KALGOORLIE TAILINGS RETREATMENT PROJECT  
KALGOORLIE, WESTERN AUSTRALIA

Report and Recommendations  
of the  
Environmental Protection Authority

Environmental Protection Authority  
Perth, Western Australia  
Bulletin 334 May 1988

**RESPONSE TO SUMMARY OF  
SUBMISSIONS RECEIVED**

**SITE SELECTION FOR  
NEW TAILINGS STORAGE  
AND TREATMENT PLANT**

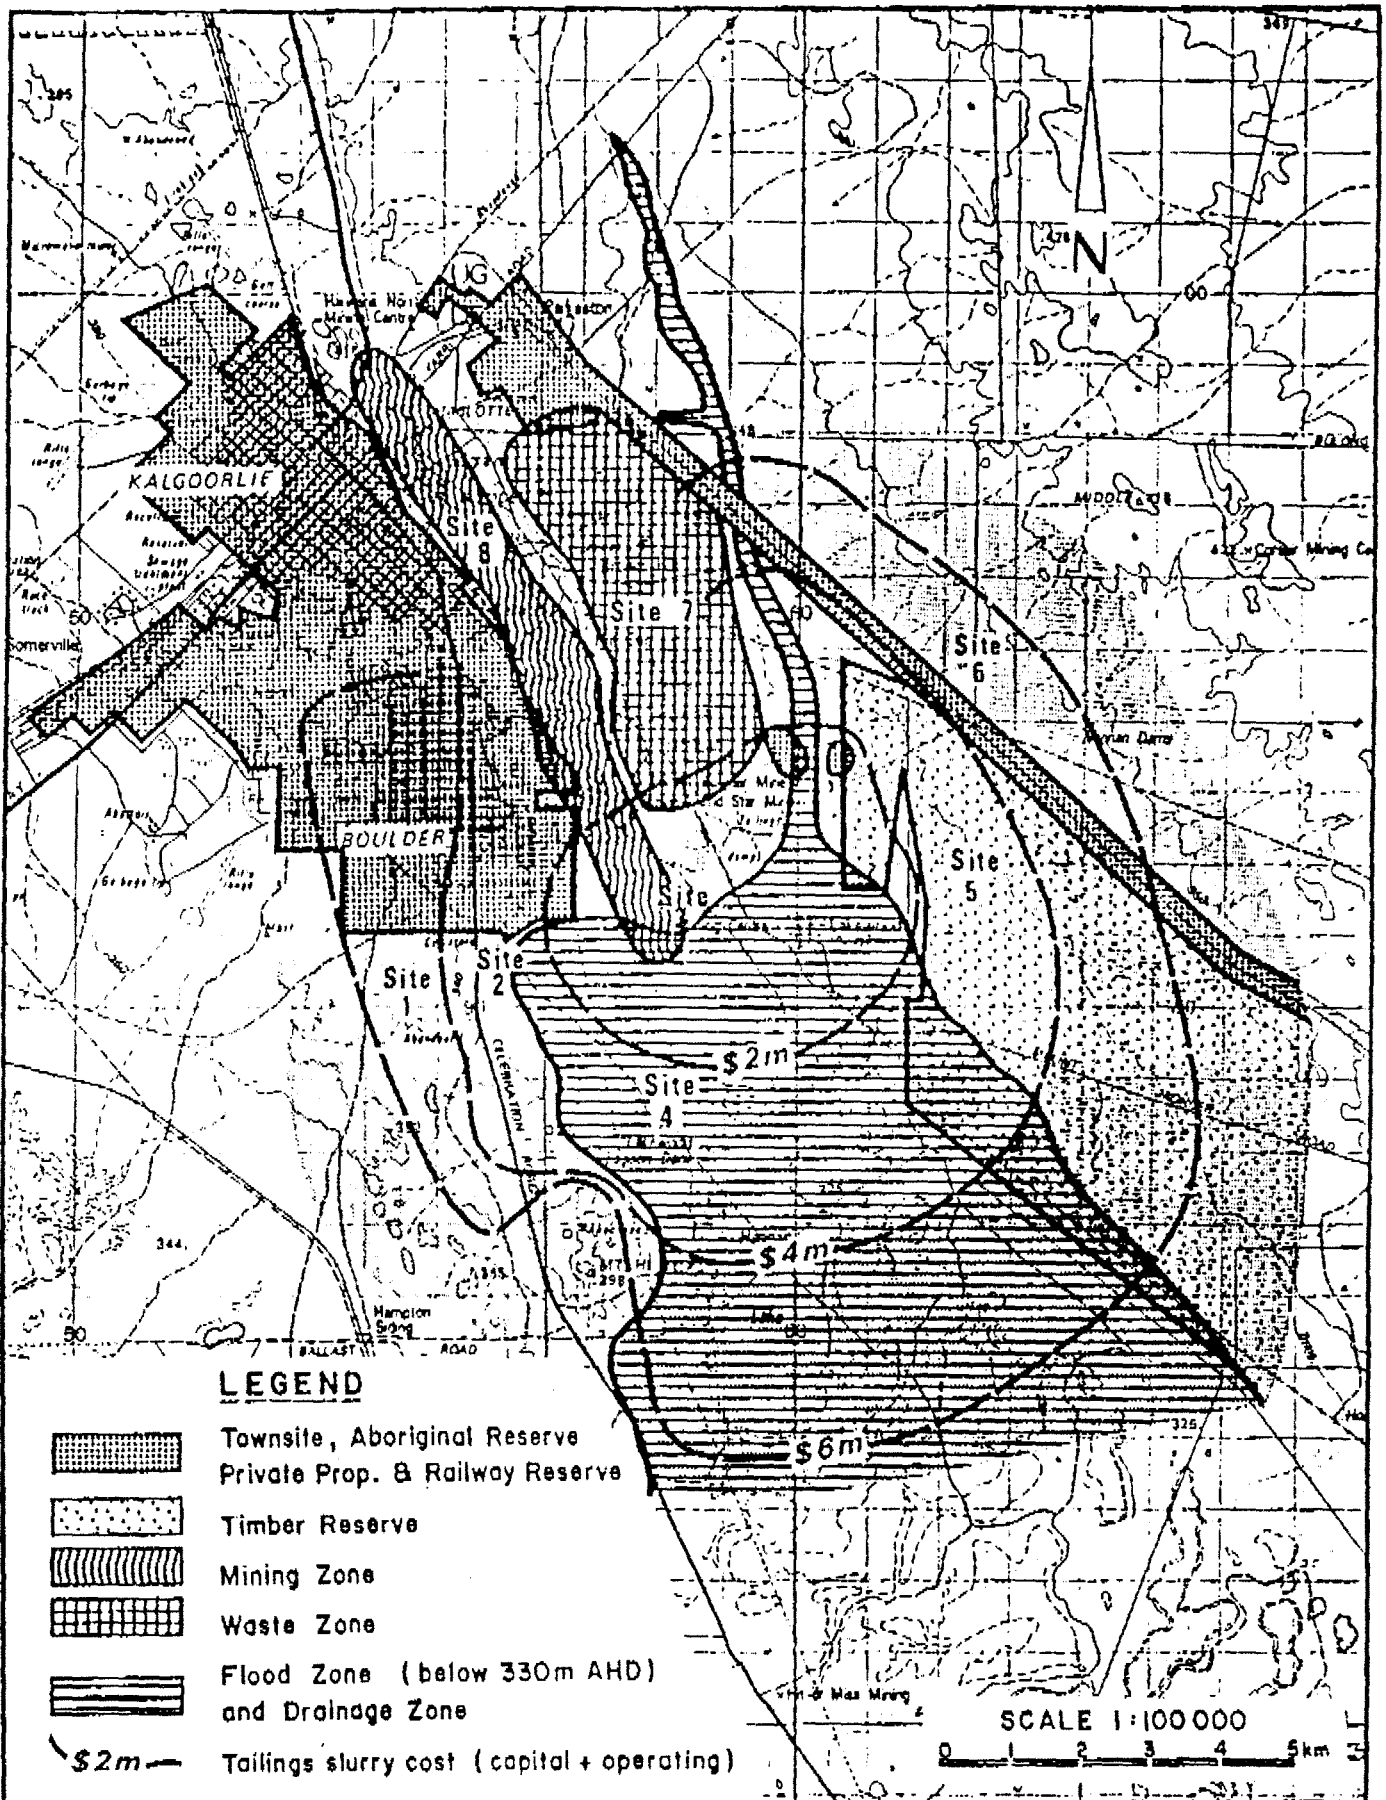
A number of submissions were concerned about the location of the tailing disposal area in a timber reserve, and that the case for dismissal of several sites was weak.

Site 3 was eliminated due to proximity to town and dusting. Dusting is unlikely to occur due to the salinity of the material and as such further review of this site is required.

Site 6 also appears to be suitable. The only consideration being financial.

Sites 1 to 8 listed in Table 9 of the PER were chosen as being representative of the areas within economic distance of the existing dumps which are not already committed to an exclusive present or future land use (refer Figure 17, from the PER, a copy of which is included with this document).

Site 2, representing areas south of Boulder on the eastern side of Celebration Road, is unsuitable for siting the tailings storage, due to the insufficient area available between the assumed flood level (330m AHD) and Celebration Road to accommodate the 320 ha plant and tailings disposal site.

Site 5 (M26/82) would involve the loss of 280ha of timber reserve (7 percent of Lakeside Reserve) which includes some areas of poorer quality, more sparsely timbered scrub near the western boundary of the Reserve. The site plans involve locating the plant, tailings storage and other facilities as close as possible to this lighter timbered zone, to minimise the impact on the better quality woodland zones.

Site 6 shown on Figure 17 in the PER is the closest site north east of the railway. However, it is considered representative of all sites north-east of the railway.
